MEMORANDUM

SUBJECT Yankovich-Miller Hill Road

Reconstruction and Multi-Use Path

Design Study Report Revisions

Figure 3: Typical Section – Yankovich Road

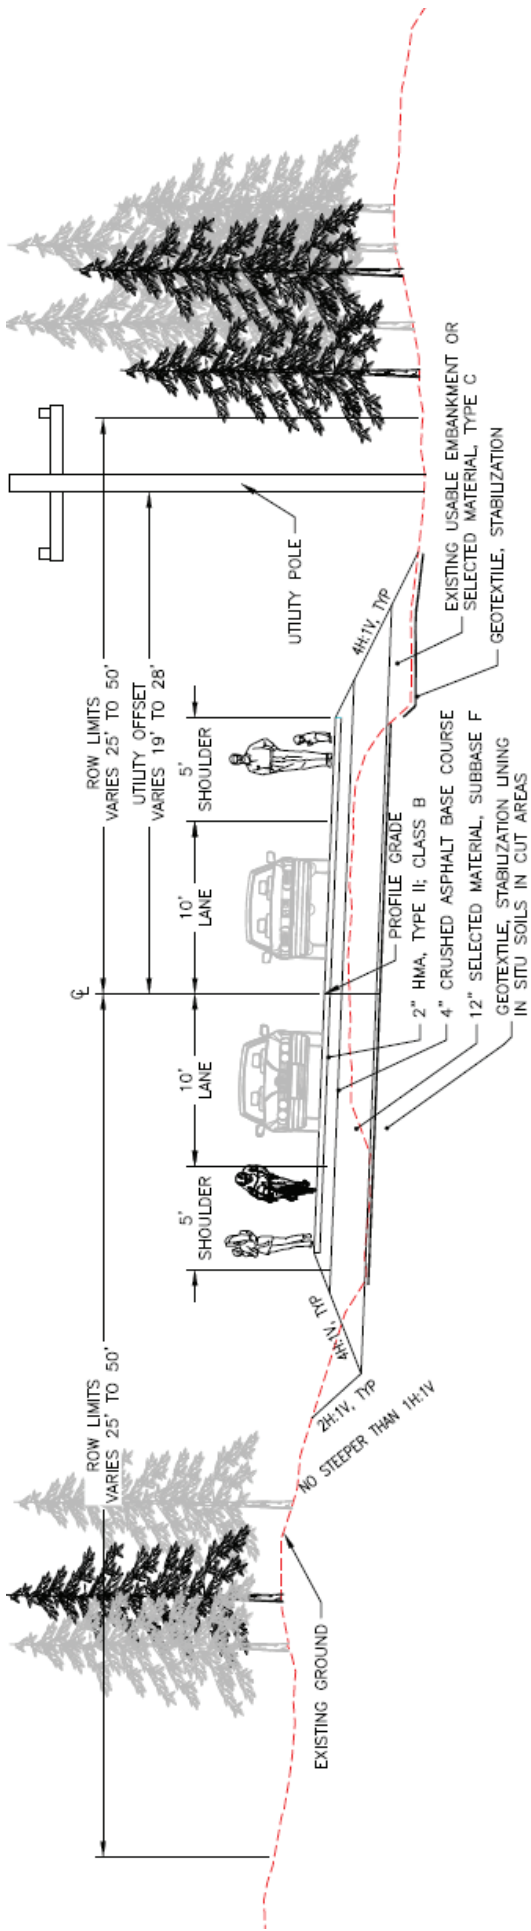
TYPICAL SECTION(S). Replace the second and third sentences with the following: Shoulders of 5 feet width will promote safety for motorized and non-motorized travel. In areas of constricted ROW, the fore slopes may be as steep as 2H:1V in fill sections and back slopes as steep as 1H:1V in cut sections.

Replace Figure 3: Typical section – Yankovich Road and Figure 4: Typical Section –Miller Hill Road with attached new typical sections
